INCH-POUND
MIL-A-18001J
AMENDMENT 2
13 March 1989
SUPERSEDING
AMENDMENT 1
7 December 1987

ANODES, CORROSION PREVENTIVE, ZINC; SLAB DISC AND ROD SHAPED

This amendment forms a part of MIL-A-18001J, dated 25 November 1983, and is approved for use by all Departments and Agencies of the Department of Defense.

FIGURE 10. ZEP heat exchanger slab."

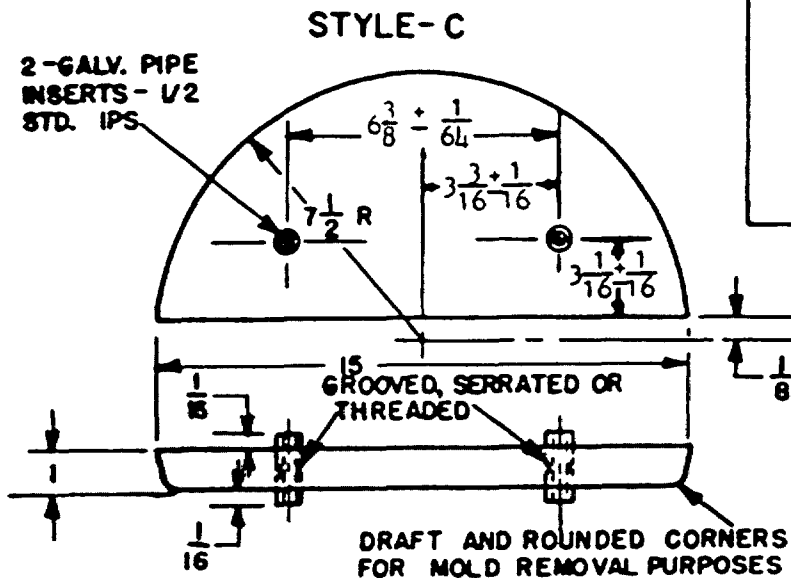
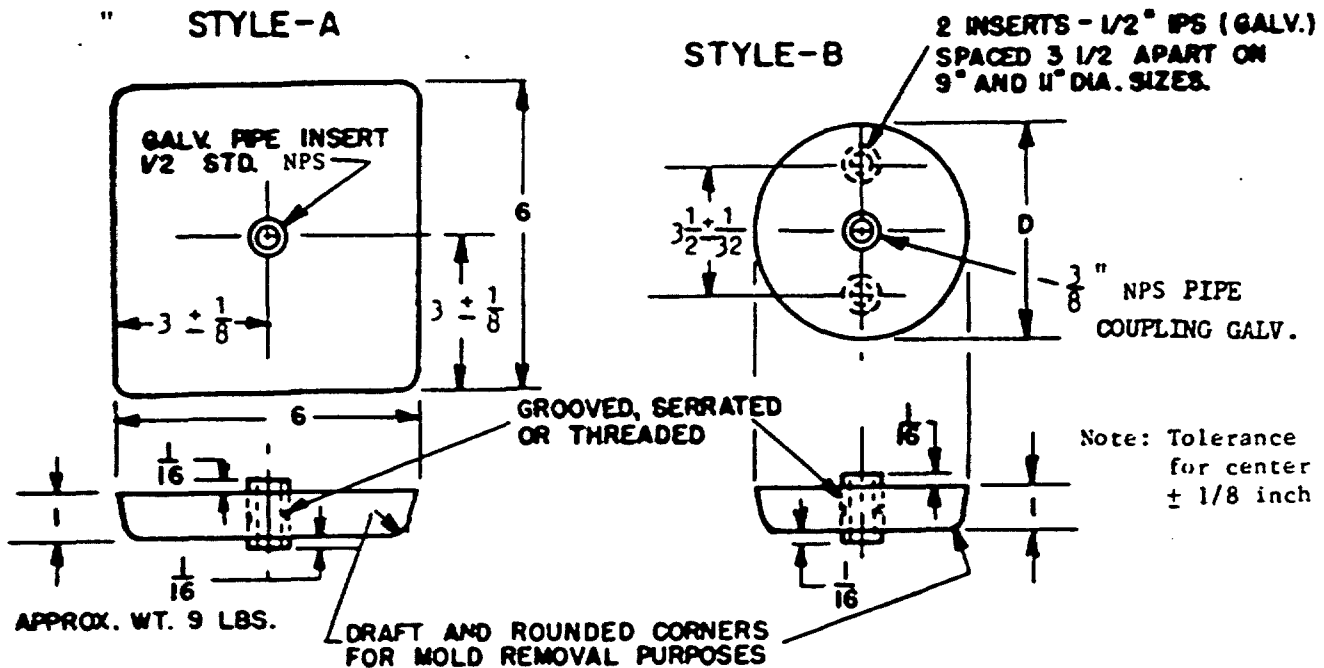
FIGURE 10: Delete and substitute.
